Subject: UniStar Nuclear Energy, NRC Docket No. 52-016
Response to Request for Additional Information for the
Calvert Cliffs Nuclear Power Plant, Unit 3,
RAI No. 253, Seismic System Analysis

**RAI 253 Question 03.07.02-46 for the ESWB and EPGB, and
Questions 03.07.02-49, 03.07.02-50 and 03.07.02-51
Seismic System Analysis**

Calvert Cliffs Nuclear Power Plant Unit 3

Figure 23. Lateral Force at South Basement Wall Location 3, ESWB

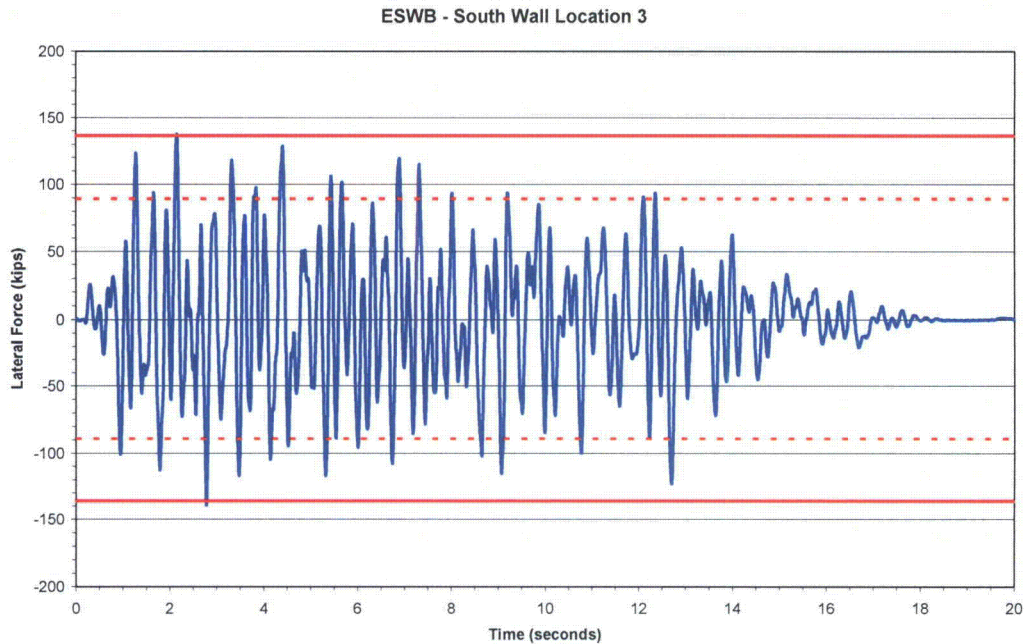
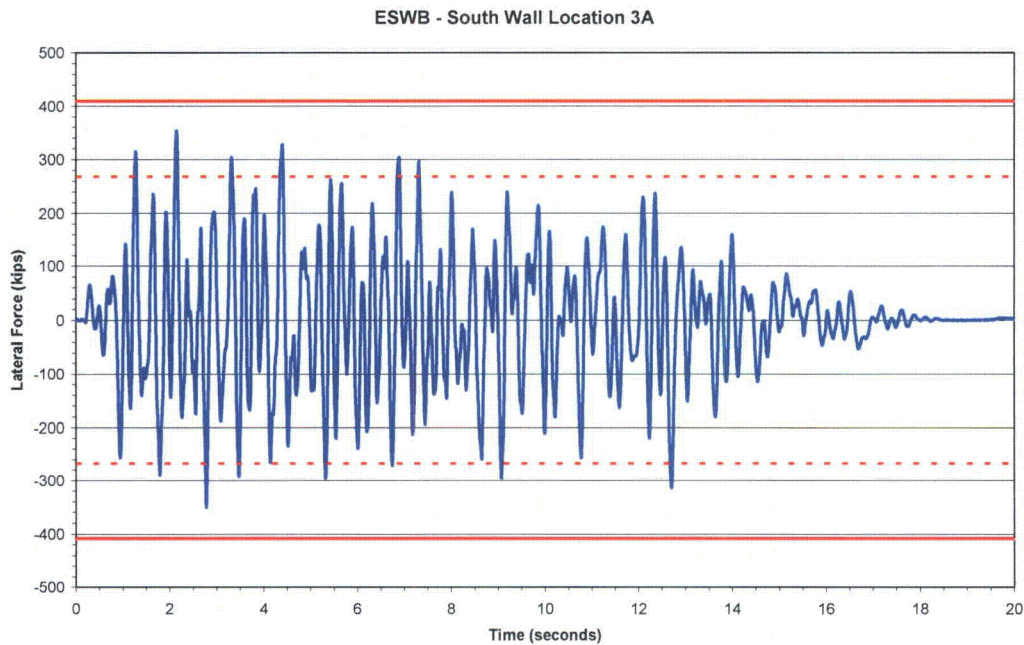
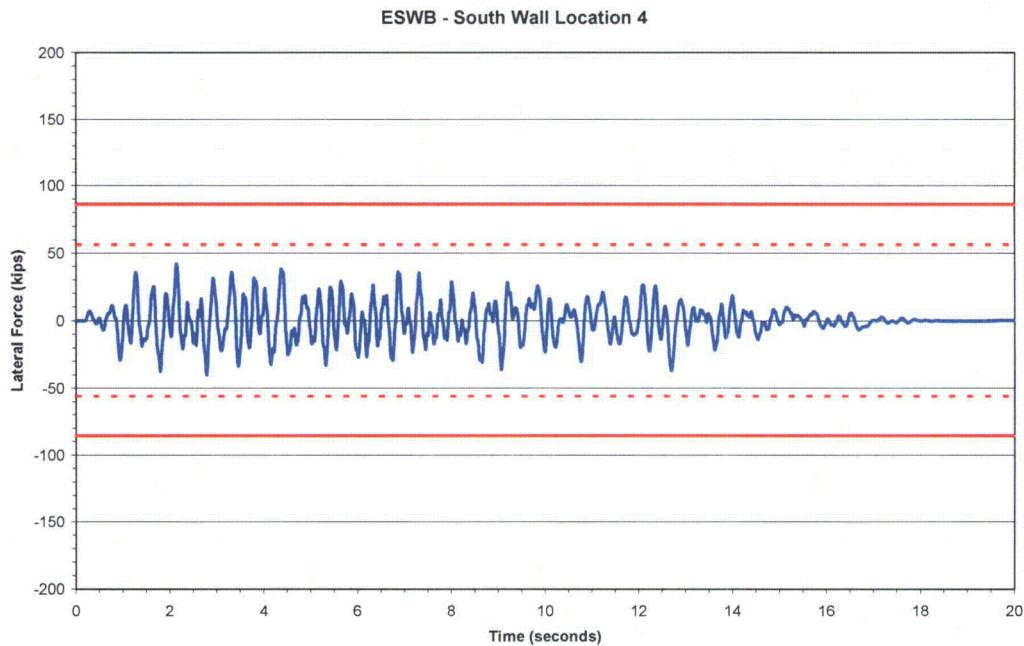
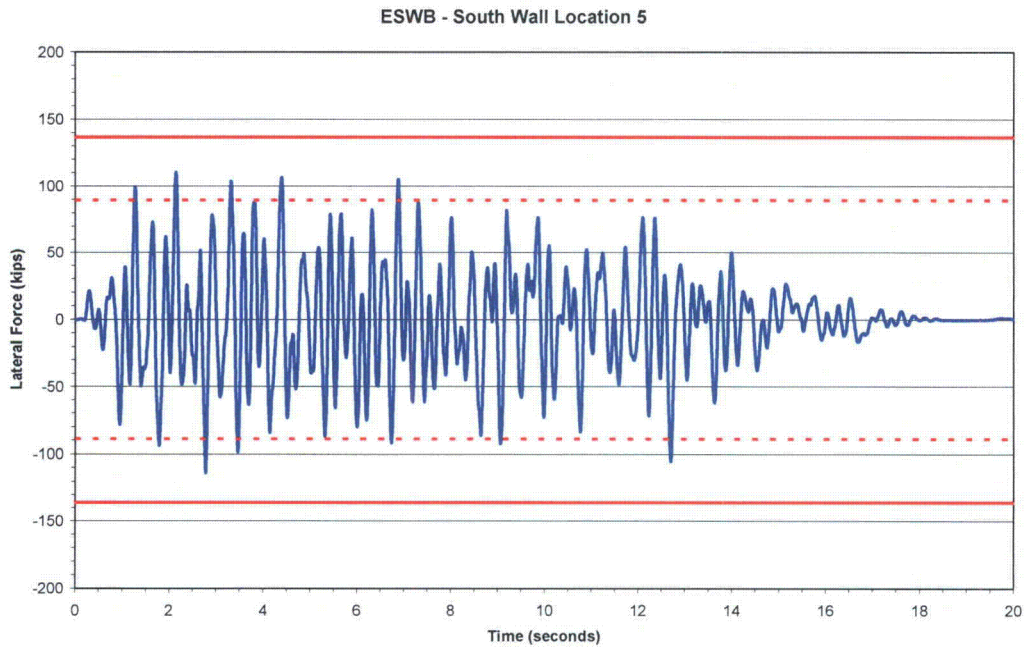
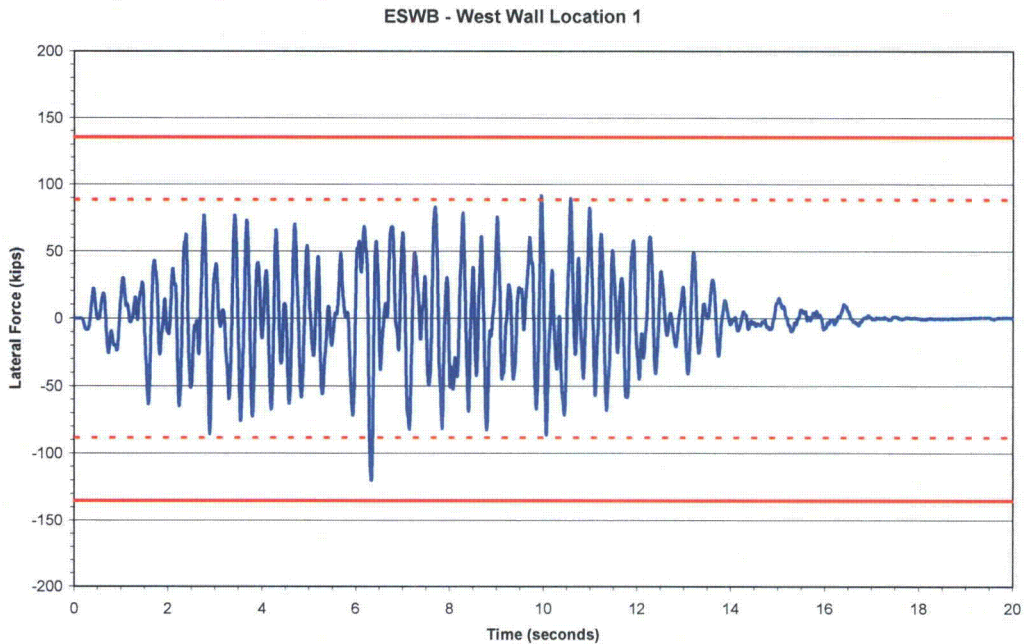
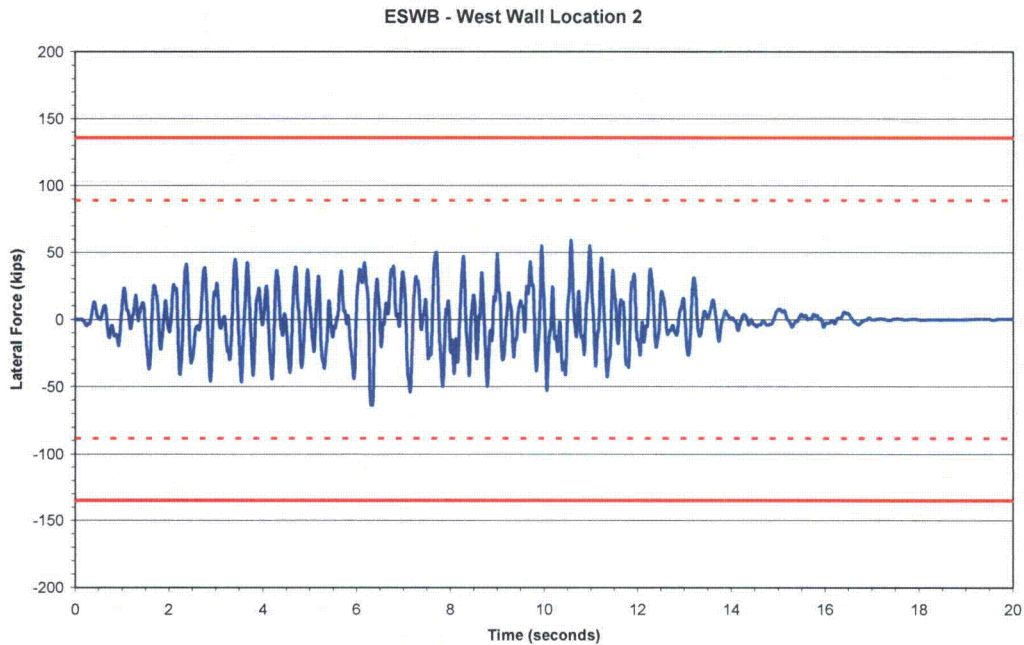
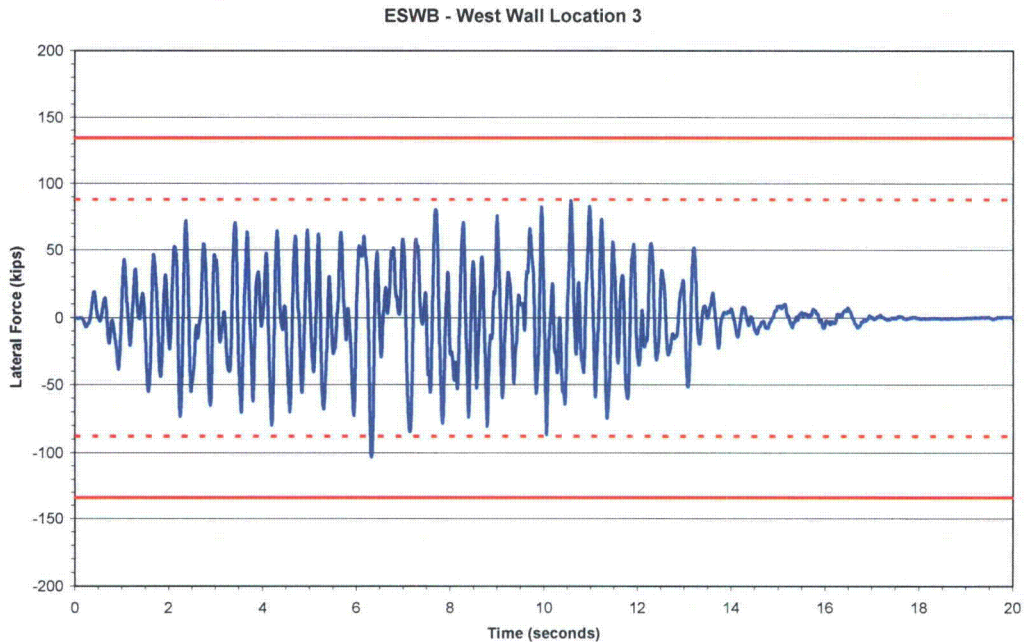
It is not clear how static and dynamic lateral earth pressures were determined in the analysis and how they contribute to the overturning and sliding factors of safety for the structures. The applicant is requested to provide a description of how lateral earth pressures were determined and if tensile soil forces are indicated between the building sidewalls and the soil to describe how these were treated in the overturning and sliding analyses.

To determine if there is separation between embedded exterior side walls and the surrounding soil, total spring forces of a vertical strip of the exterior wall (in the normal to the exterior wall direction) from the SSI analysis of the controlling upper-bound soil case are compared to the static lateral soil pressure. These total spring forces are calculated using the same approach as those used in the above summation of net vertical spring forces below the basemat. It is noted that this evaluation is performed for the ESWB only since the EPGB is a surface founded structure without embedded walls. The static lateral soil pressure is obtained by estimating compaction-induced earth pressures from the grade down to a depth that equates the at-rest soil pressure and then by following the at-rest soil pressure to the embedment depth of the embedded walls. No water pressure is applied since the post construction ground water level is approximately 30 ft below grade, which is below the basemat of the ESWB.

The comparisons at various selected locations of the ESWB (see Figure 11) are shown in Figure 12 through Figure 29. In these figures, solid red lines are static compressive soil pressure (force) for the tributary width of the sidewalls, based on the static soil pressure used for structural design of the embedded walls; and dotted red lines are a lower bound estimation of the static soil pressure (force) for reference. It is noted that Figure 17 and Figure 18 show comparison at the same location (see Figure 11), with Figure 18 (North 3 A) representing a wider tributary width of the basement wall. Similarly, Figure 23 represents a wider section of the south basement wall than Figure 24.

These comparisons show that there is only a limited number of exceedance where the tension forces between the wall and the soil are higher than the static lateral soil pressure (force). These exceedances are highly localized and very short in duration. Therefore the effects of soil separation at the basement walls on the results of the ESWB SSI analyses are concluded to be negligible and the embedded exterior walls are considered to be always in contact with the side soil.

Figure 30
Isometric View of the Western Half of the CBIS with Additional
3D Finite Elements for the Seismic Stability Evaluation

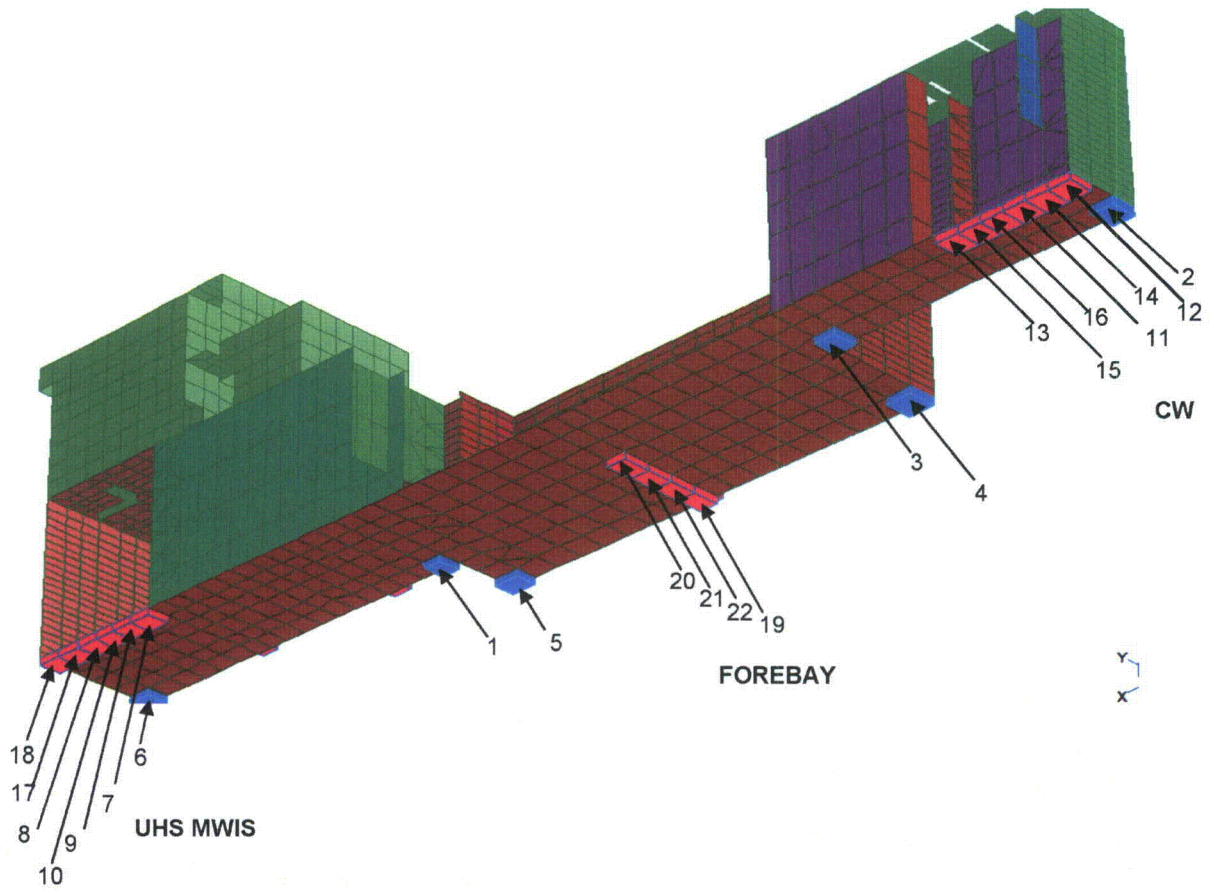
The applicant stated that the results of the SASSI analysis are used for the overturning and sliding calculations of the EPGB, ESWB, CBIS, and UHS EB. The applicant is requested to describe whether or not during the seismic response of these structures there exists a vertical tensile force between the bottom of the basemat and the supporting subgrade. Since this would indicate an uplift of the mat where such a force is indicated, the applicant is requested to describe the effect this has on the results of the overturning and sliding analysis and whether the results of these analyses can be considered as valid if such an effect exists.

- For seismic stability evaluation of the CBIS, 3D finite elements with soil properties were introduced to the SASSI model at the bottom of the MWIS foundation (as shown on Figure 30). The additional 3D soil elements were added at selected regions where sliding and overturning are expected to be critical. The selected regions for the additional 3D finite elements are: the corner of the half model, the region below the UHS MWIS, the region under the center of the Forebay, and the region below the CW building.

- After seismic analysis of the CBIS using the UB, LB and BE soil conditions, and excluding stabilizing static compressive stresses, the maximum tensile stresses due to seismic forces between the foundation of the CBIS and the additional finite soil elements were evaluated. It is important to note that maximum tensile stresses during seismic motions can occur at different times for different regions. However, for conservative evaluation of the stability of the CBIS, the maximum tensile stresses were considered simultaneously, regardless of the time they occurred.

- In addition to the SASSI seismic analysis, the stabilizing compressive static stresses at the foundation of the CBIS were computed from a static PLAXIS 3D analysis. Finally, the seismic tensile stresses obtained from SASSI were superimposed with the stabilizing static compression stresses obtained from PLAXIS 3D in order to obtain the resultant tensile stresses at the base of the CBIS. Tables 1, 2, and 3 show the solid elements considered at the base of the CBIS (shown on Figure 30) together with the maximum tensile stresses from the seismic SASSI analysis and the compression stresses obtained from the PLAXIS 3D analysis. The results show that the stabilizing static compressive stresses are larger than the seismic tensile stresses at all selected regions below the CBIS basemat foundation. This result confirms that no tensile stress is observed between the foundation of the CBIS and the supporting soil.

Figure 31
Schematic View of Western Half of CBIS Foundation Floor

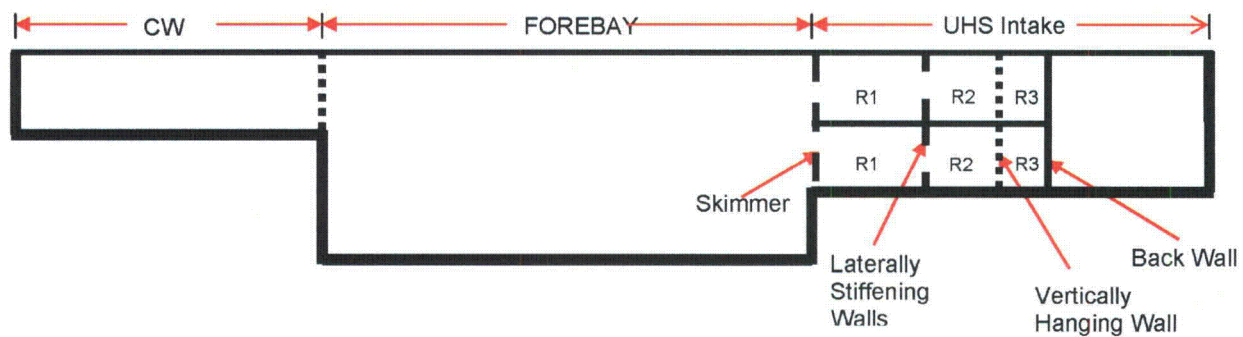
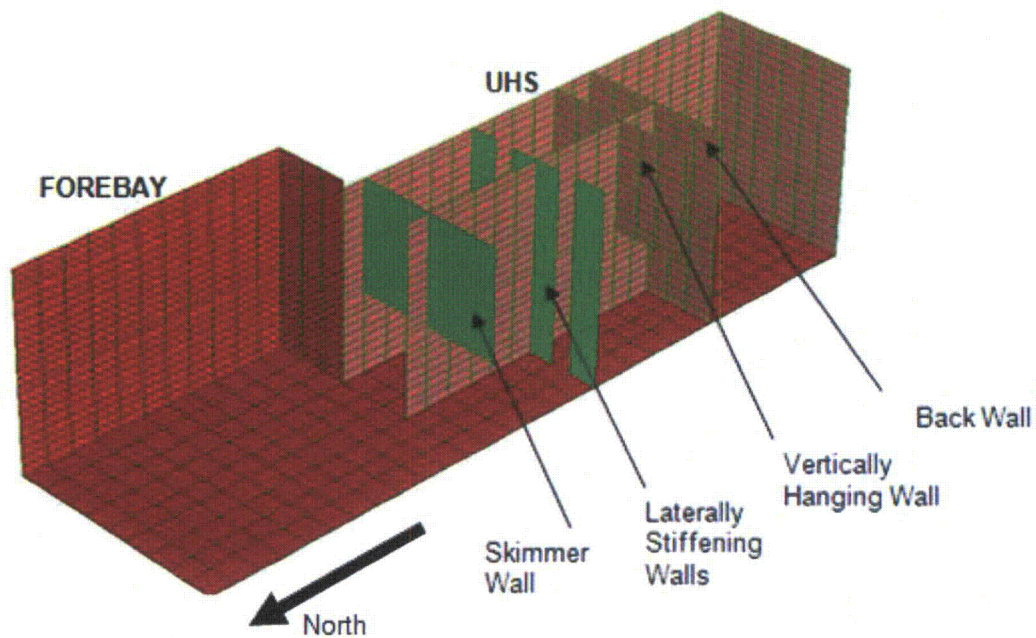
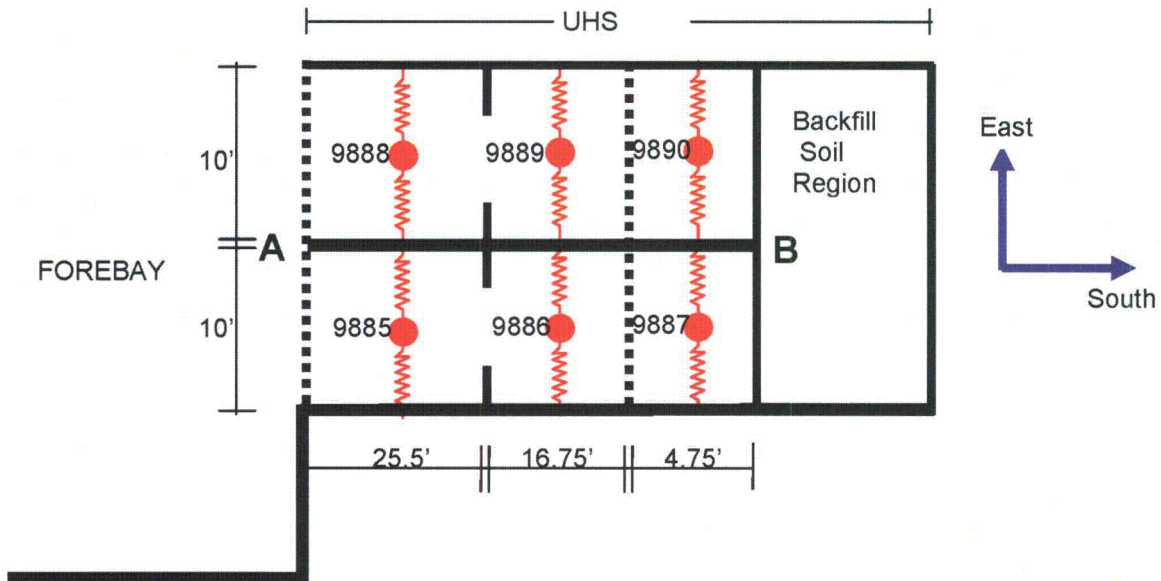
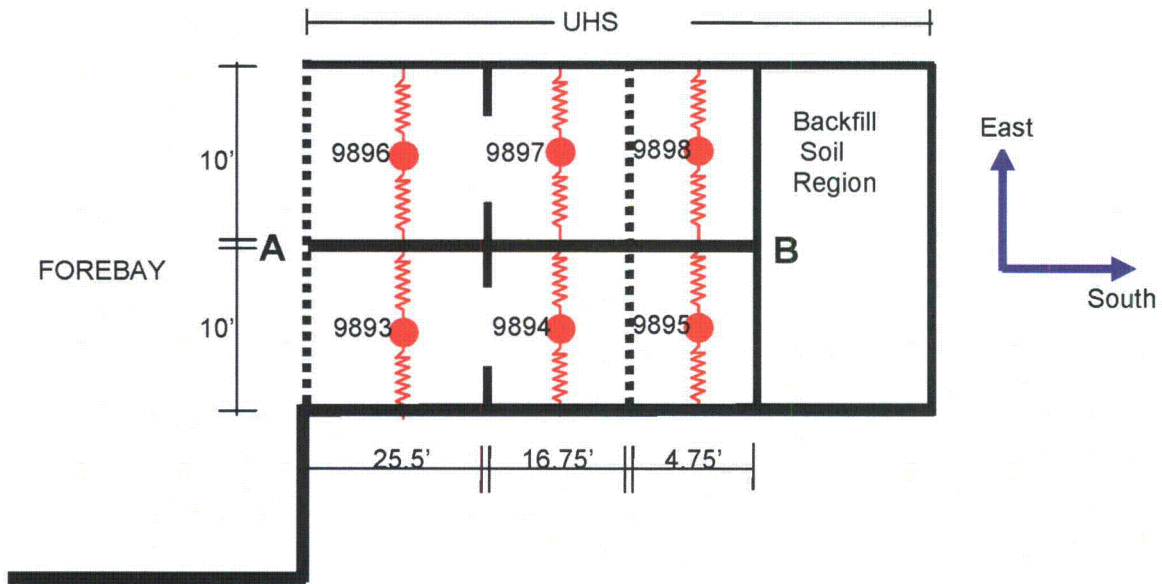
In its response, the applicant states that interior walls carry impulsive pressure on both sides of the wall as shown in Figure 2 included in the response. In evaluating the net pressure distribution on an interior wall, for a given direction of earthquake excitation, the hydrodynamic pressure increases on one side of a wall and decreases on the other side by the impulsive force that is generated within each chamber. Thus there is a net increase on the hydrodynamic load acting on any given wall. The applicant is requested to confirm that this effect is considered in the wall design and include its description in the FSAR. In addition the applicant states on page 3-38 that the entire water mass is lumped at the basemat when determining the seismic response in the vertical direction. The hydrodynamic pressure of the water mass acting on the sides of the wall needs to be increased to reflect its acceleration in the vertical direction. The applicant is requested to revise the FSAR to state that this effect is also considered in the wall design. The information requested will assist the staff's analysis to conclude that the effects of fluid-structure interaction have been properly accounted for in the seismic design of the building.

To compare the magnitude of the horizontal hydrodynamic load due to vertical and horizontal seismic vibration, the corresponding forces and bending moments are computed on an internal wall A-B inside the UHS MWIS room below grade.

Figure 31 shows a schematic view of the western half of the CBIS basemat floor, which was considered in the SSI analysis of the CBIS. Figure 32 shows an isometric view of the detail of the UHS MWIS walls subjected to hydrodynamic loads. Figures 33 and 34 show schematic views of the water storage area inside the UHS MWIS, together with the convective and impulsive hydrodynamic nodes and springs in the East-West direction. The SASSI simulation results, which correspond to the upper bound (UB) soil with 5% critical damping ratio, were used to get the maximum accelerations at the location of the hydrodynamic mass nodes and at the basemat floor.

Table 5 summarizes the bending moment acting at the base of the internal UHS MWIS wall A-B from horizontal hydrodynamic forces due to horizontal and vertical seismic vibrations. The results in Table 5 show that the horizontal hydrodynamic forces from horizontal seismic vibration (convective and impulsive loads) are much larger than the horizontal hydrodynamic loads from vertical seismic vibration.

Hence, the contribution of vertical seismic excitation on horizontal hydrodynamic loads acting on walls is extremely small (less than 2%) and does not have any significance on the design. This leads to the conclusion that the effect of the vertical vibration on the horizontal hydrodynamic loads is negligible and does not impact the design of the CBIS walls.
